Subject: Notification of a Class 1 Permit Modification to the Waste Isolation Pilot Plant
Hazardous Waste Facility Permit Number: NM4890139088-TSDF

Update Panel Closure Information

**Waste Isolation Pilot Plant
Carlsbad, New Mexico**

WIPP Permit Number - NM4890139088-TSDF

Figure A2-1
Repository Horizon

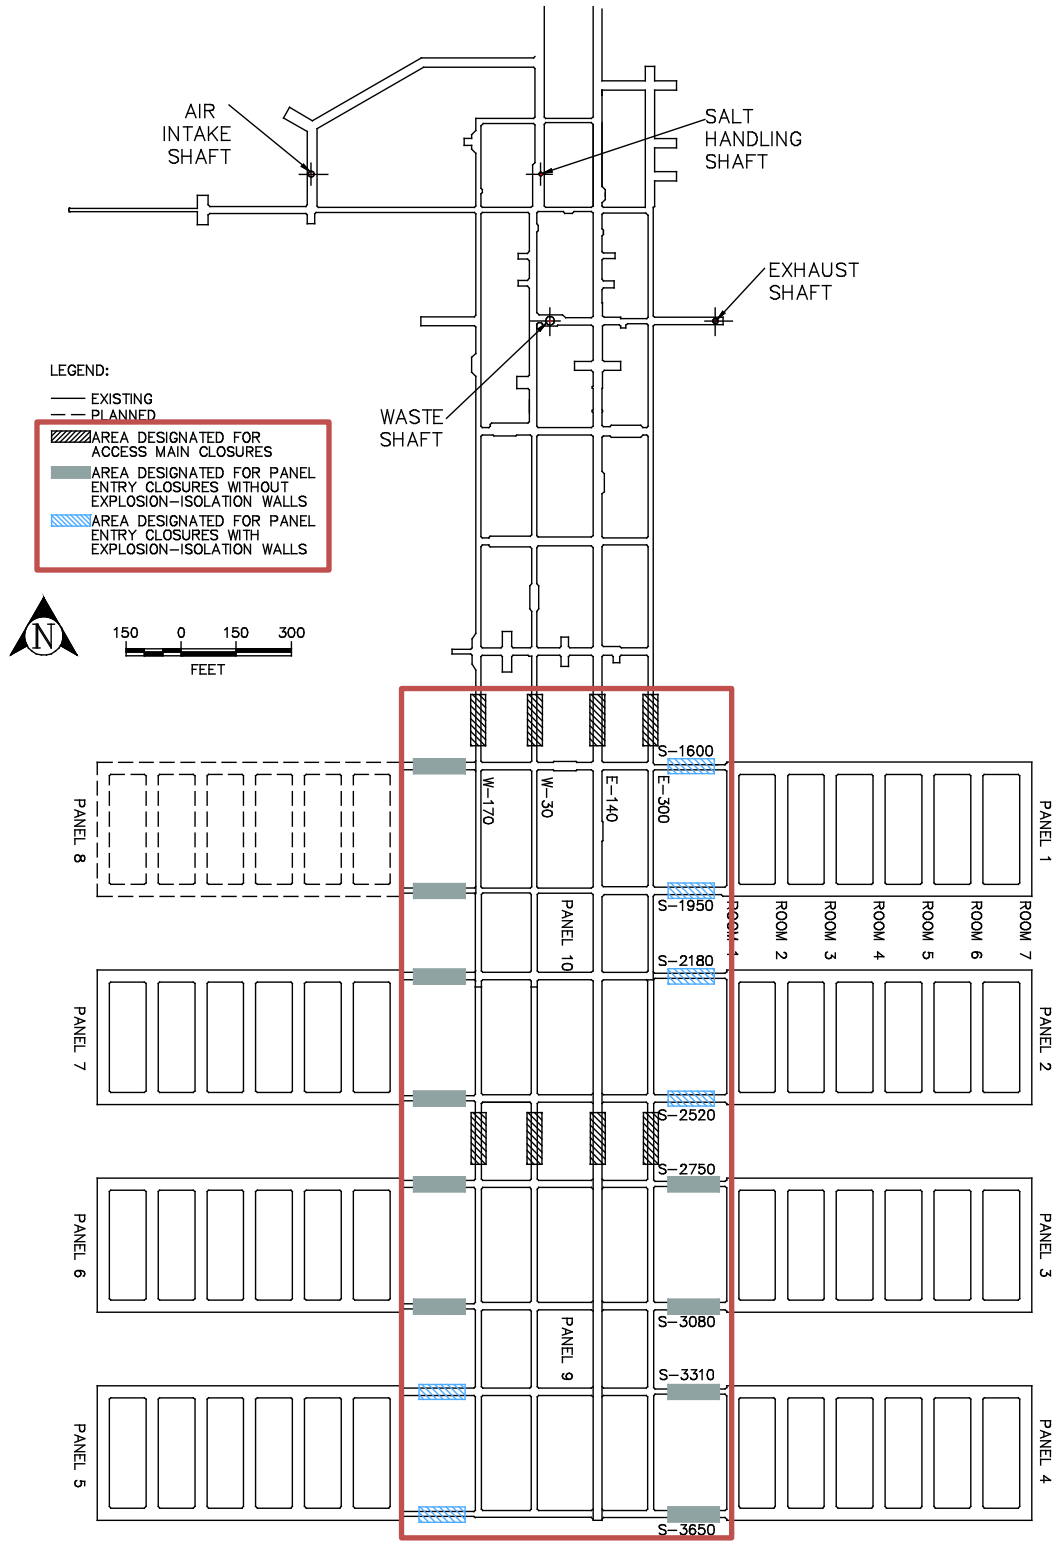
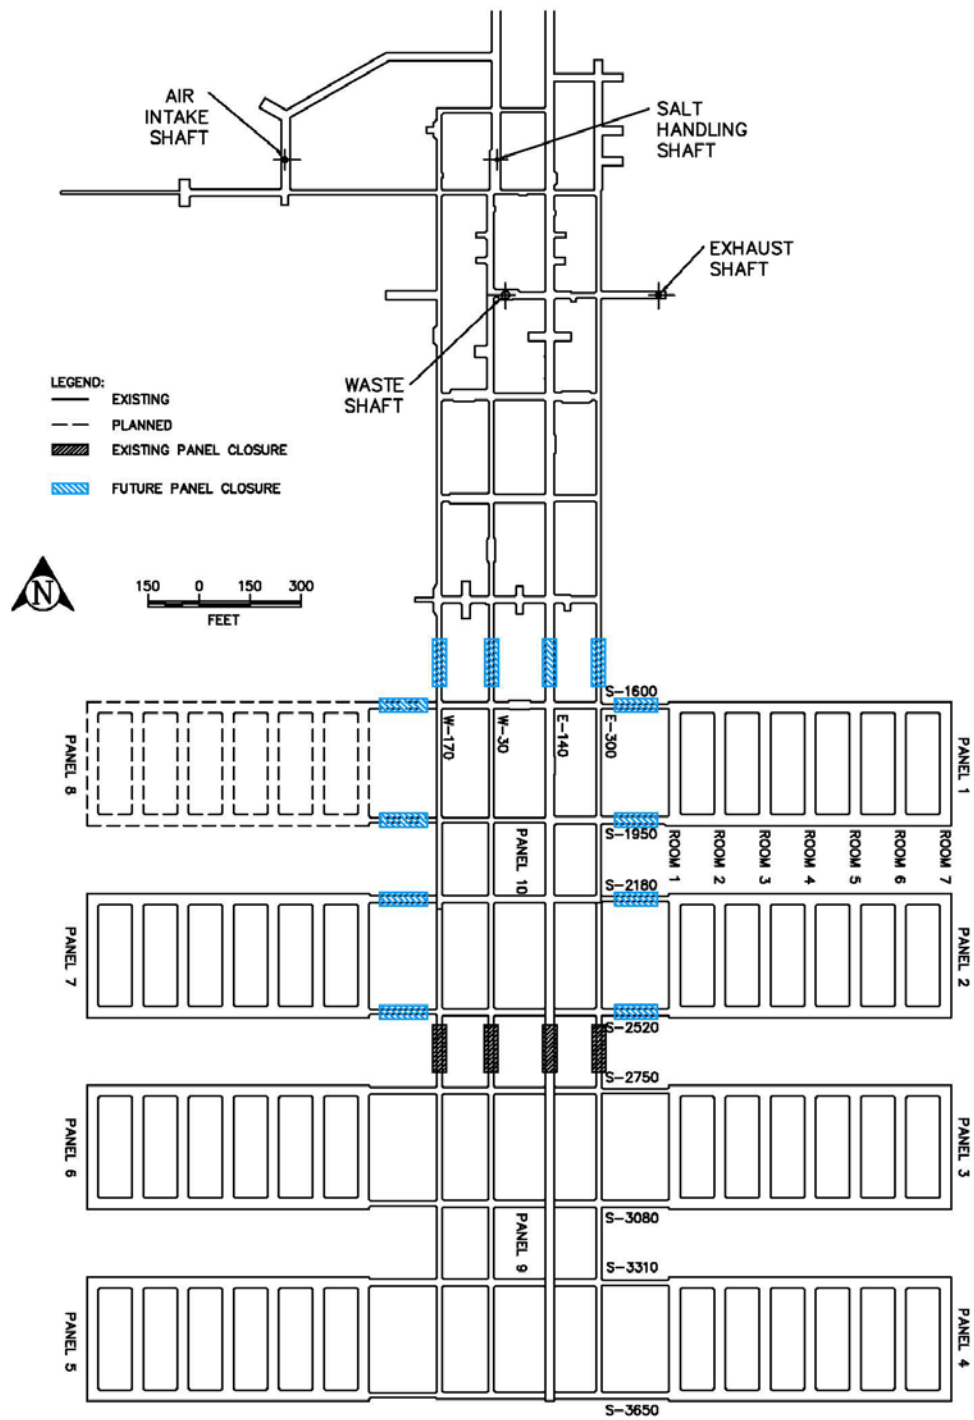
- Permit Attachment A2, Figure A2-1, *Repository Horizon*; Permit Attachment B, Figure B3-2, *Repository Horizon*; Permit Attachment D, Figure D-7, *Designated Underground*

- Changed “AREA DESIGNATED FOR ACCESS MAIN CLOSURES” to “EXISTING PANEL CLOSURE” in the figure legend.
- Removed “AREA DESIGNATED FOR PANEL ENTRY CLOSURES WITHOUT EXPLOSION-ISOLATION WALLS” from the figure legend.

- Changed “AREA DESIGNATED FOR PANEL ENTRY CLOSURES WITH EXPLOSION-ISOLATION WALLS” to “FUTURE PANEL CLOSURE” in the figure legend.
- Revised the markers on the underground layout to correspond with the new figure legend as follows:

- Changed the markers for the Panels 1, 2, 7, 8 and 10 closures to future panel closures.
 - Changed the markers for Panel 9 to existing panel closures.

- Removed the markers for Panels 3 through 6.
- Permit Attachment A2, Figure A2-2, *Spatial View of the Miscellaneous Unit and Waste Handling Facility*, Permit Attachment B, Figure B3-1, *Spatial View of the WIPP Facility*, and Permit Attachment D, Figure D-2, *Spatial View of the WIPP Facility*

Figure A2-2
Spatial View of the Miscellaneous Unit and Waste Handling Facility

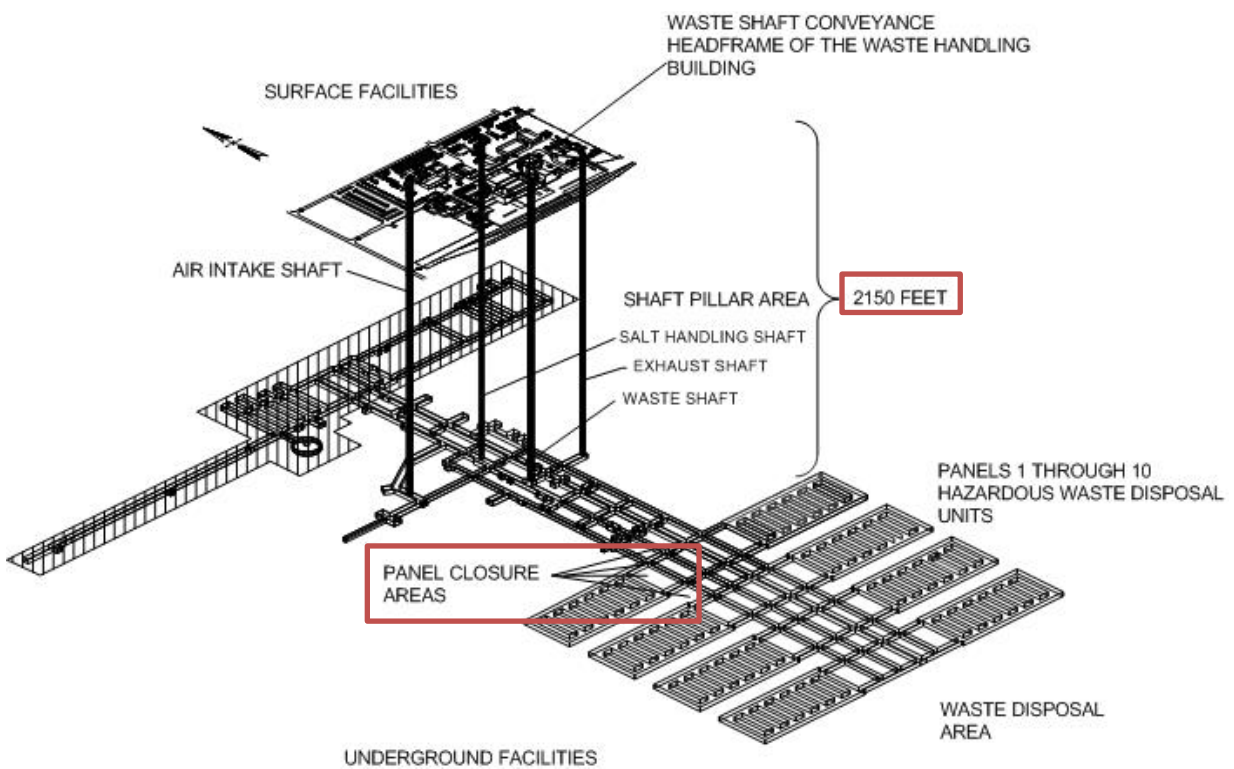
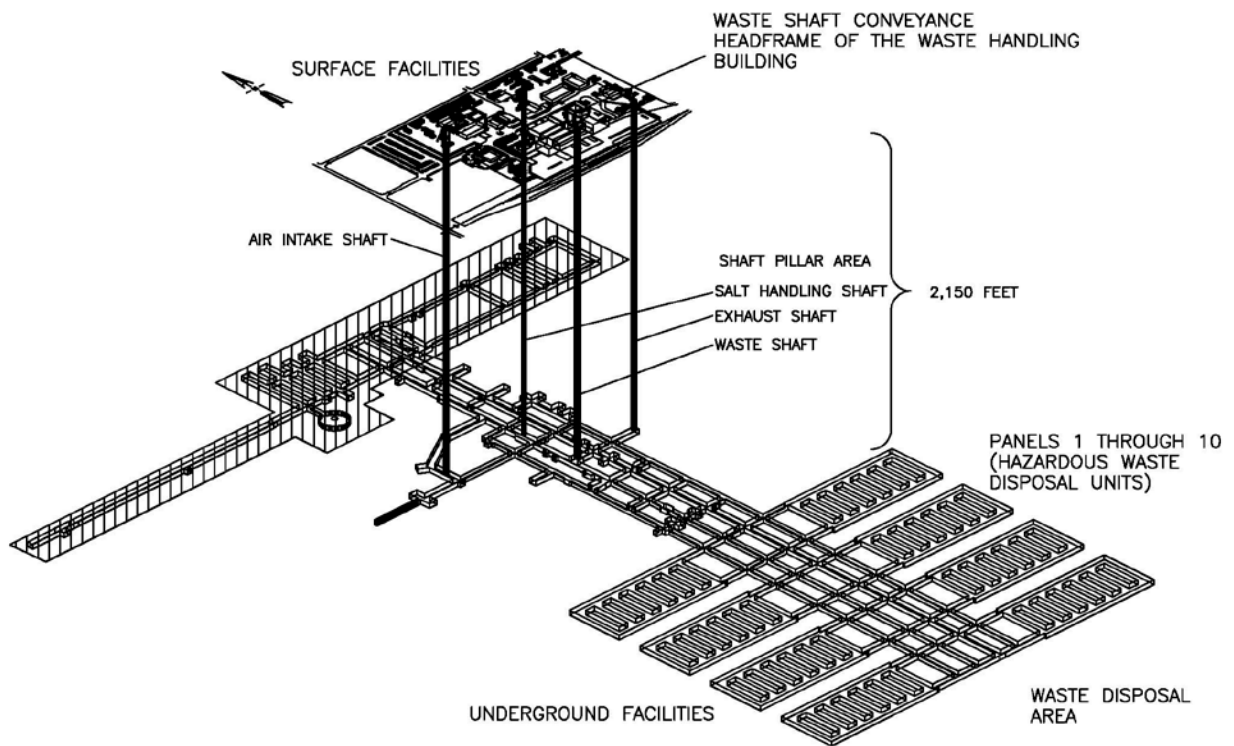
- Removed the panel closure label.
 - Added a comma to “2150” to read “2,150.”
- Permit Attachment G, *List of Figures*
 - Changed the figure title from “Location of Underground HWDUs and Anticipated Closure Locations” to “Location of Underground HWDUs and WPC Locations.”

Figure D-7
Designated Underground Assembly Areas

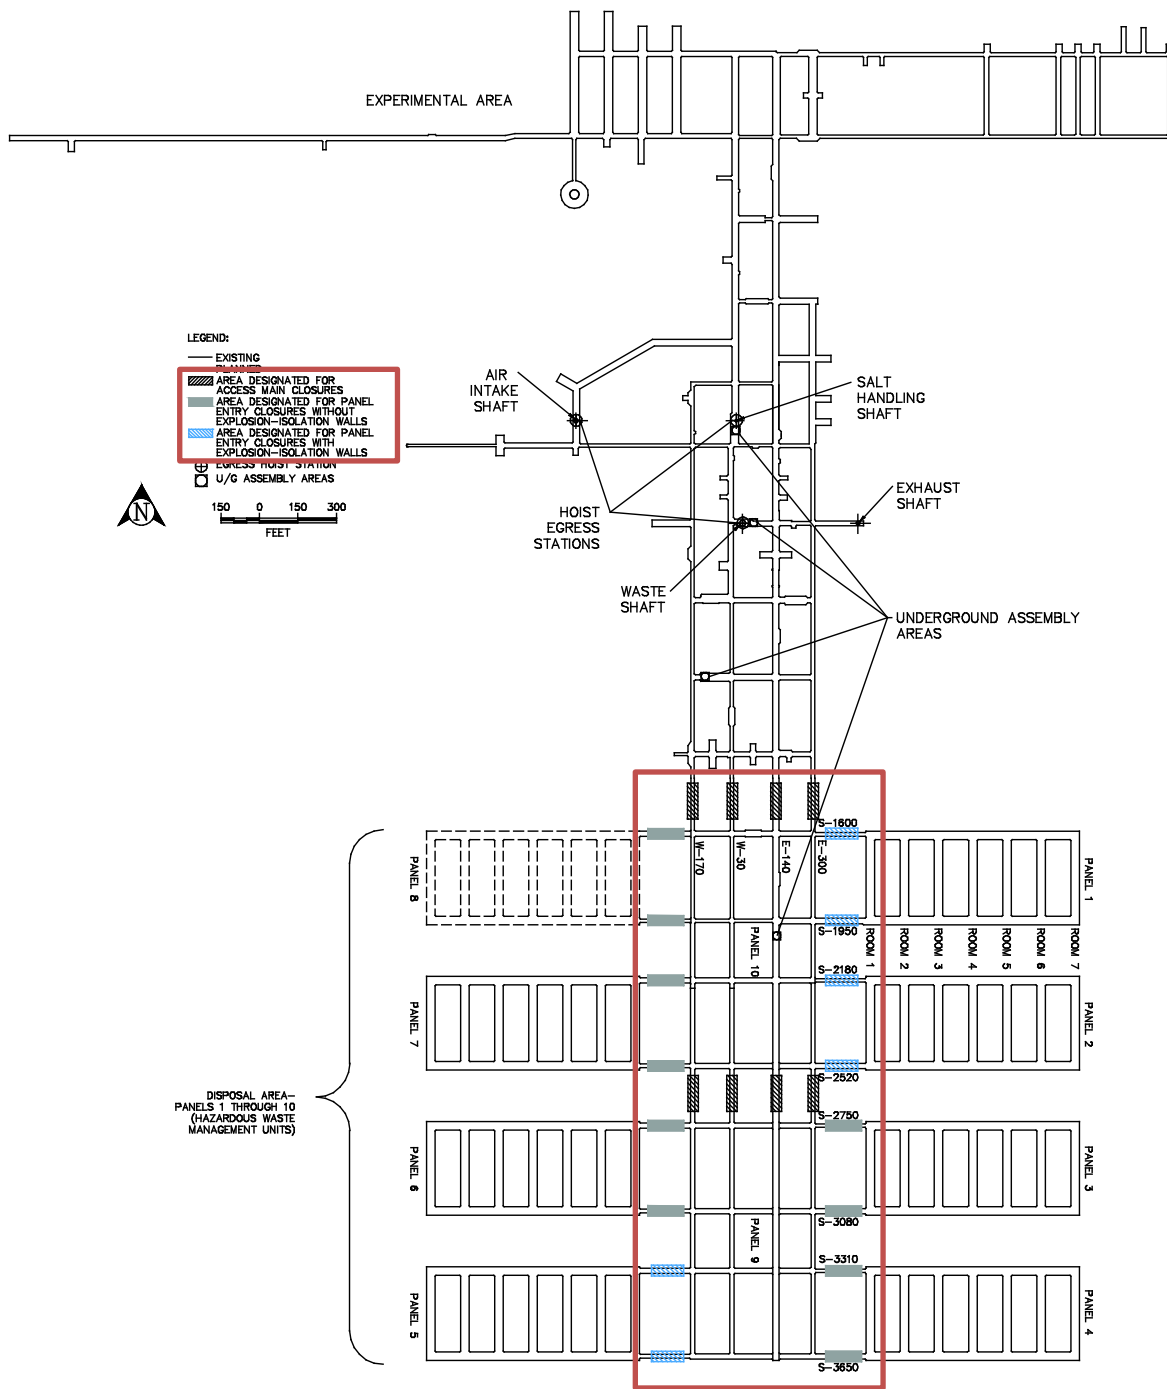
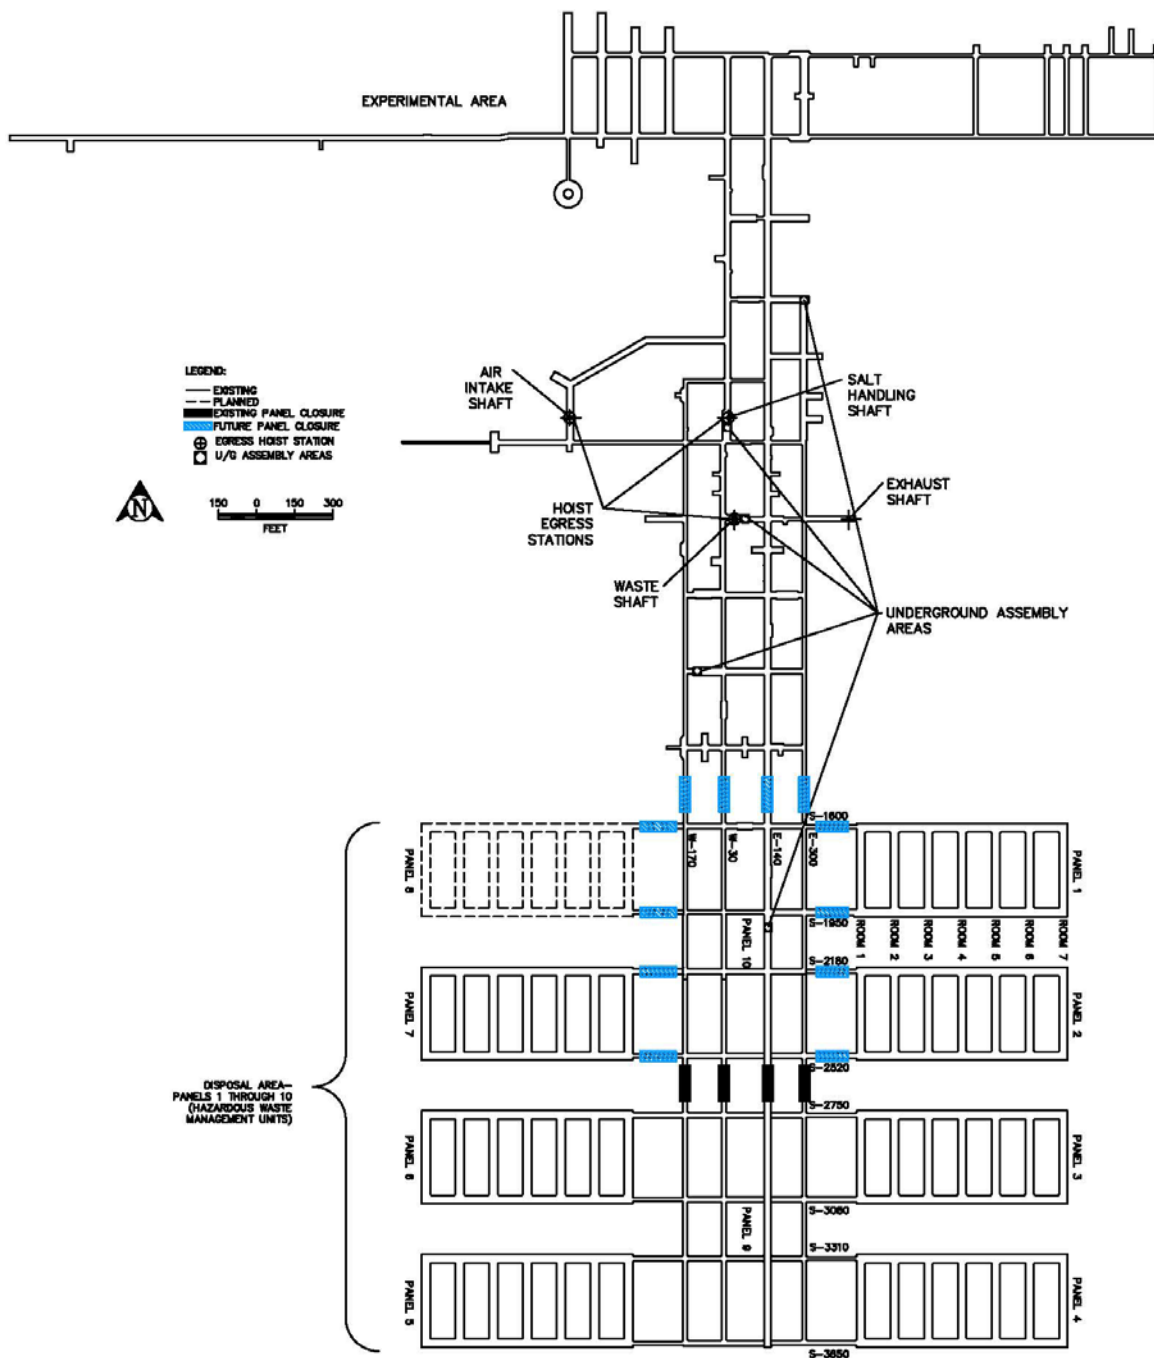
Assembly Areas; Permit Attachment G, Figure G-1, Location of Underground HWDUs and Anticipated WPC Locations; Permit Attachment G, Figure G-6, Approximate Locations of Boreholes in Relation to the WIPP Underground
